*RESPONSE TO COMMENTS ON DESIGN MONITORING
AND EVALUATION PROGRAM PLAN*

DOE-1068-93

RESPONSE TO COMMENTS ON DESIGN MONITORING AND EVALUATION PROGRAM PLAN

Document No.: 05TE07159201 Rev. No.: 0 Rev. Date: 7/15/92 OU NO.:
 Title: South Plume - Design, Monitoring, and Evaluation Program Plan PO NO.:
 Comments Due To: FERMCO
 Reviewer: Ohio EPA Doc. Status: D

DMEPP APPROACH

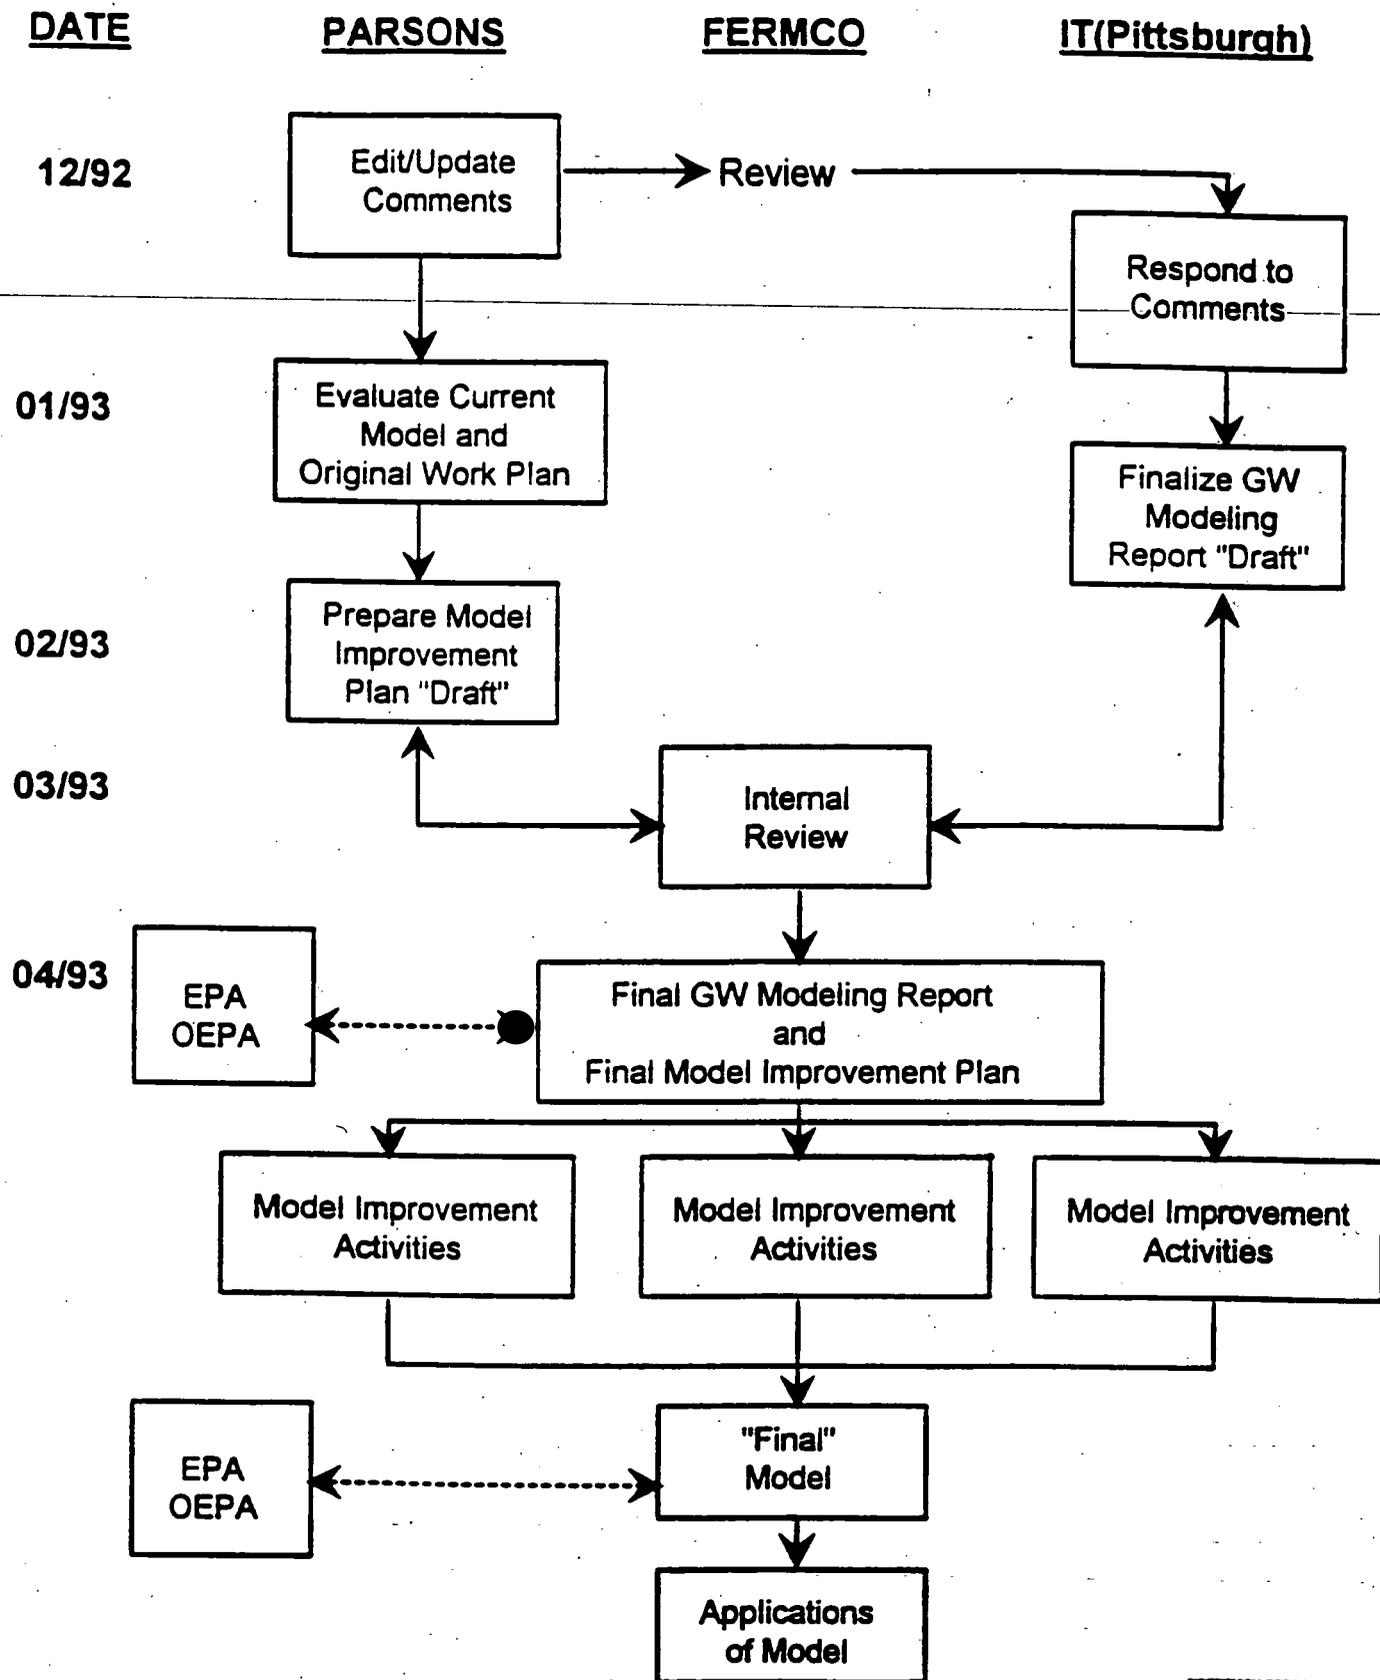
- 6 Page 1-5, Lines 27-30 - The ground water model has never been properly calibrated nor has it ever been validated. The lines should be revised to read "The pump test data will be used to calibrate the model. Over time, field measurements will be obtained and compared to predicted values in order to validate the model.

Pump test data will be used to calibrate the model and field measurements collected over time will be used to validate modeled predictions. The attached diagram (Attachment A) illustrates how DMEPP activities integrate with modeling calibration and validation. This strategy was also presented at a Technical Information Exchange Meeting which took place on January 7, 1993.

To summarize the process, the site groundwater model was used to determine initial operating conditions for the extraction wells; objectives being to create a hydraulic barrier and minimize impact to PRRS contamination. Engineering contingencies have been incorporated into the design of the extraction system to account for uncertainties in initial operating conditions defined by the groundwater model. Pump test and additional field data will be used to set final operating conditions for the wells and to calibrate the site groundwater model.

The groundwater model will be calibrated to pump test calculations. Once calibrated, it will be used to predict operational performance of the well field. Field data will be collected and used to validate the modeled predictions throughout the operational life of the system and the useful life of the model. If the model fails to meet validation criteria, it will be calibrated again. The DMEPP will be revised to include a model calibration.

Text will be revised in the DMEPP to use the pump test data to calibrate the site model. A process will be included within the DMEPP to check the ability of the model to match field data over time.
